City of Portland, Maine – Building or Use Permit Application 389 Congress Street, 04101, Tel: (207) 874-8703, FAX: 874-

Location of Construction: 336 Capisic St	Owner: Sheree Craig	Phone: 871-0170	Permit No: 97057
Owner Address: SAA Ptld, ME 04102	Lessee/Buyer's Name:	Phone:	BusinessName:
Contractor Name: Shawn Pools	Address:	Phone:	Permit Issued: JUN 10 1997
Past Use: 1-fam	Proposed Use: Same	COST OF WORK: $ 8,585.00	PERMIT FEE: $ 65.00
		FIRE DEPT. ☐ Approved ☐ Denied Signature:	INSPECTION: Use Group: Type: Signature:
Proposed Project Description: Install A/G Pool (24' Dia) Construct Deck (Steve Leighton)		PEDESTRIAN ACTIVITIES DISTRICT (P.A.D.) Action: Approved ☐ Approved with Conditions: ☐ Denied ☐ Signature: Date:	
Permit Taken By: Mary Cresik	Date Applied For: 05 June 1997

REASON FOR PERMIT: Deck & Swimming pool A/G.

CHECK-LIST AGAINST ZONING ORDINANCE

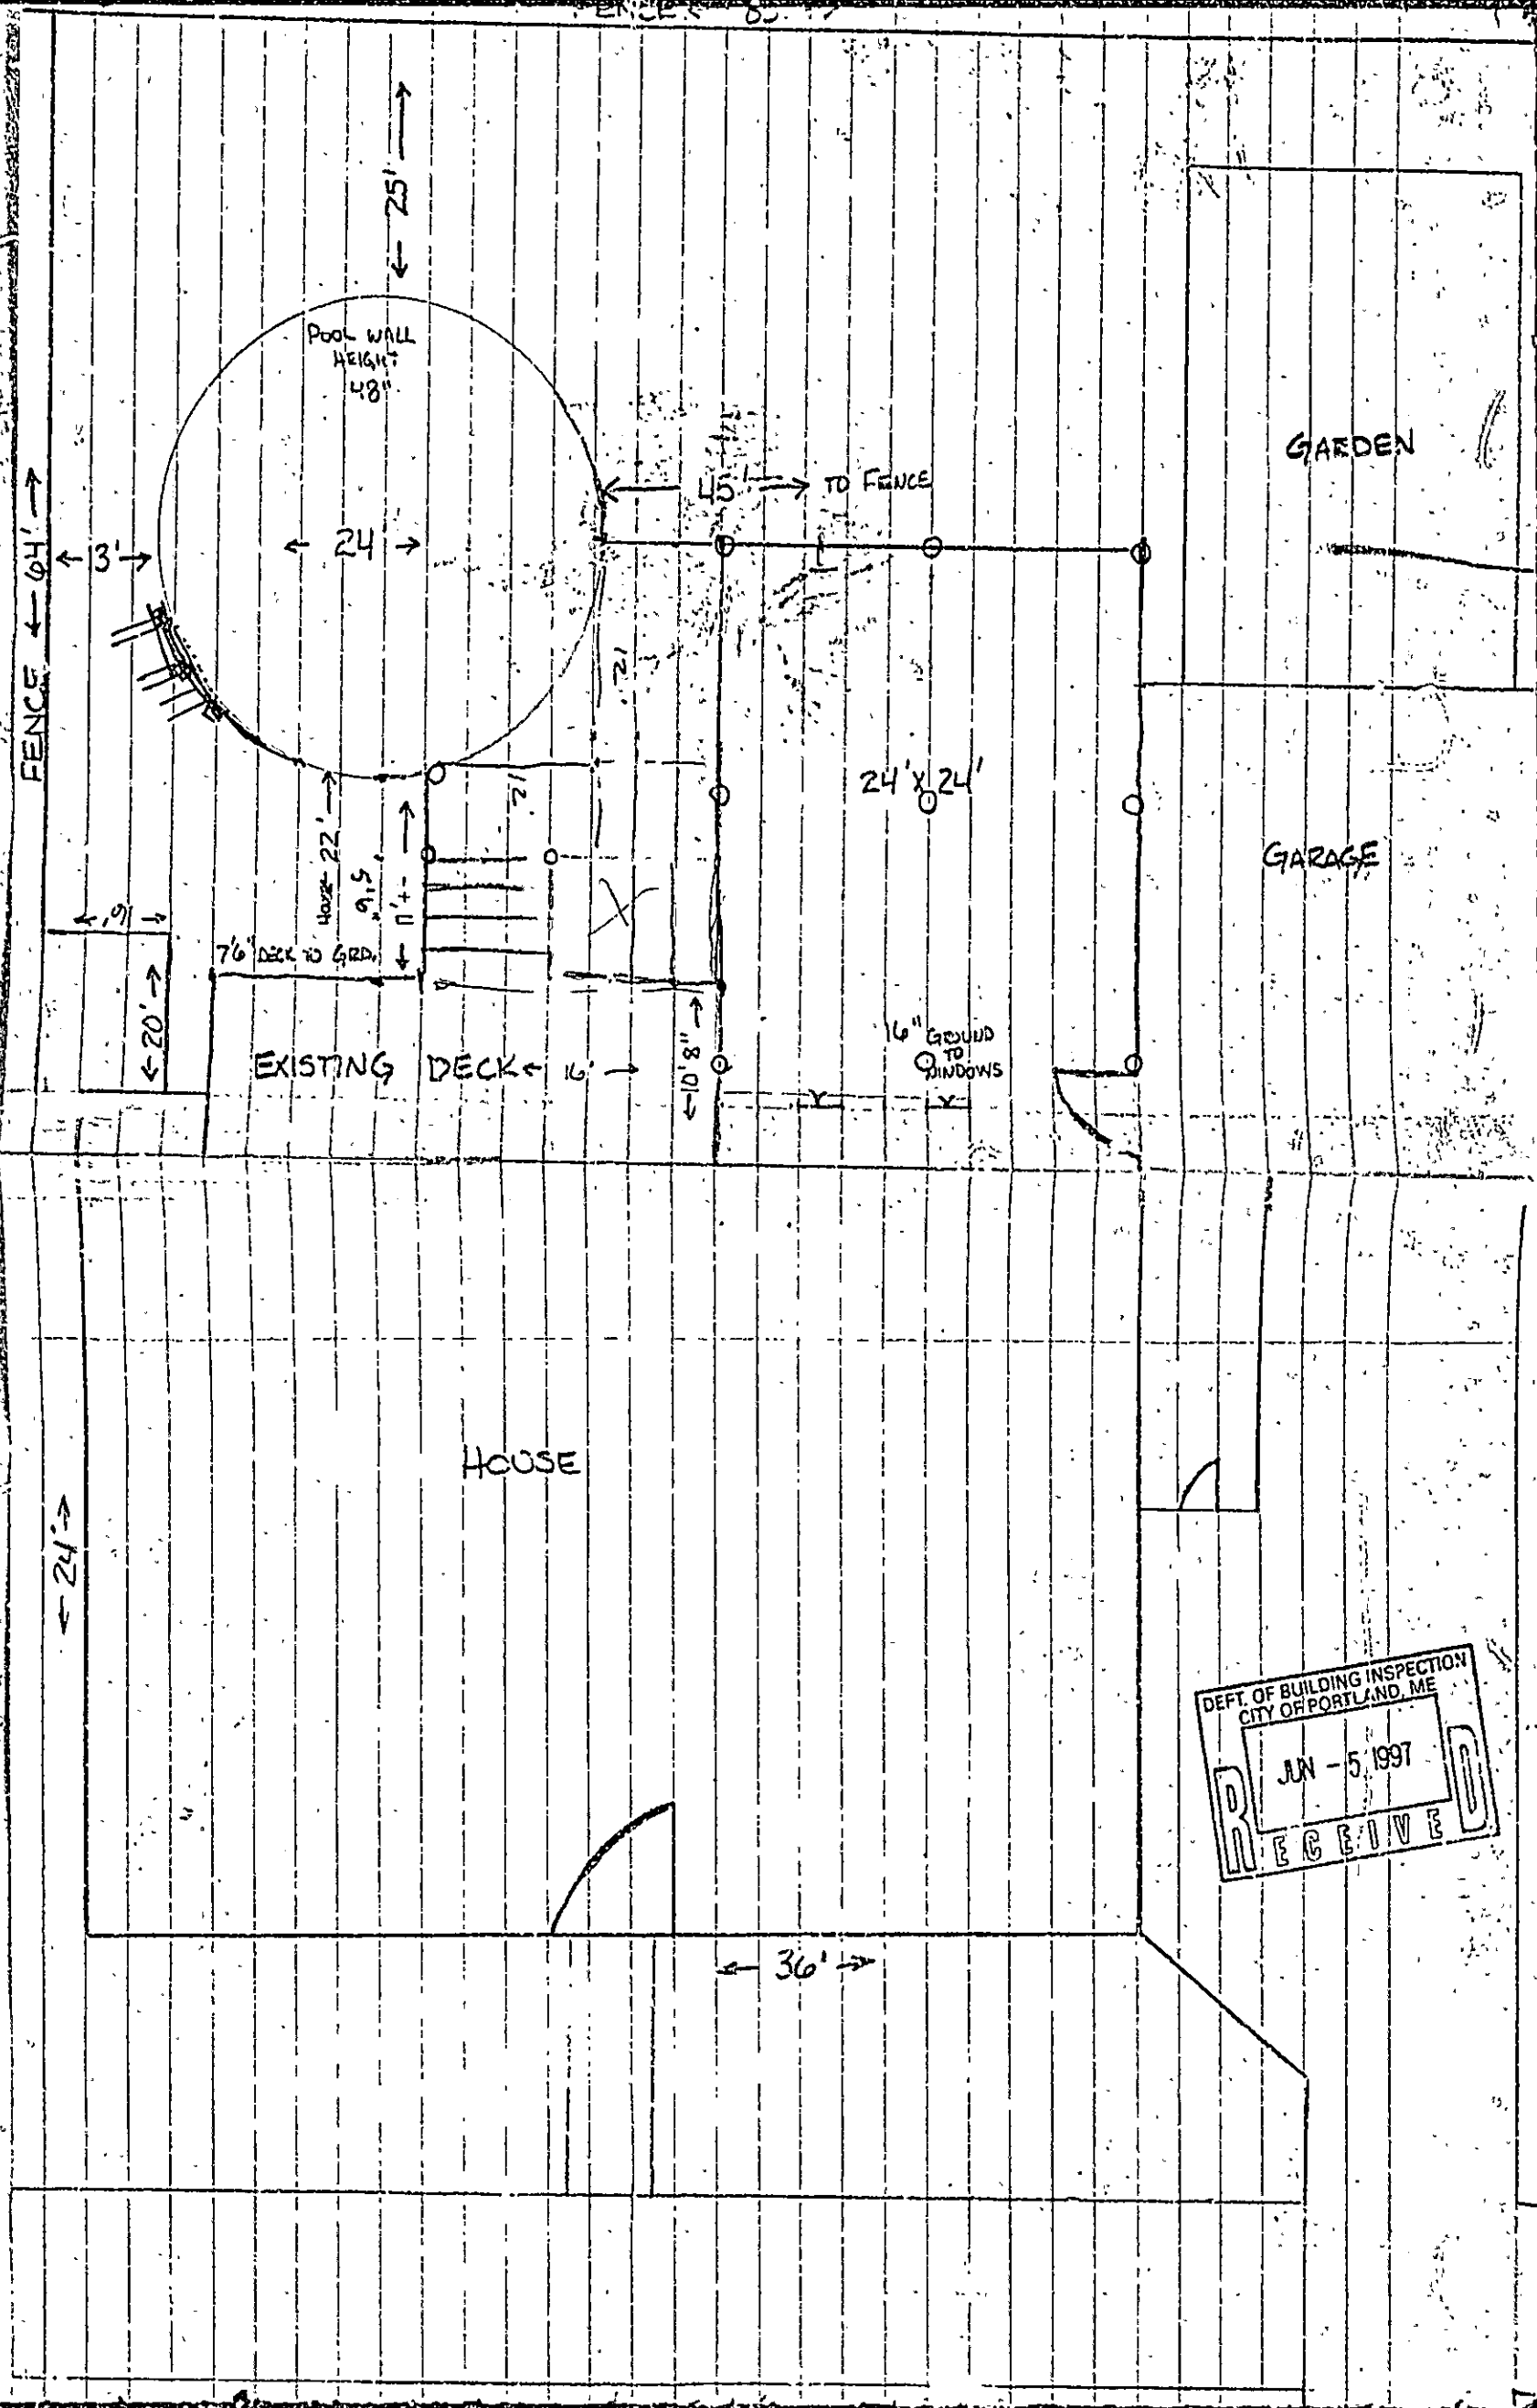
Proposed Use/Work - erect 24' Diam pool & Deck 12X17 = 204
24X24 = 576
780 ft

Rear Yard - 25' req - 25' + Shown

Side Yard - Pool → 10' req - 25' shown
10' req for pool - 13' shown
8' req for deck - 13' shown

Lot Coverage/ Impervious Surface - 25% = 2472.75 ft MAX

12X16 = 192
25X30 = 750
9X14 = 126
14X24 = 336
1404 ft
780
2184
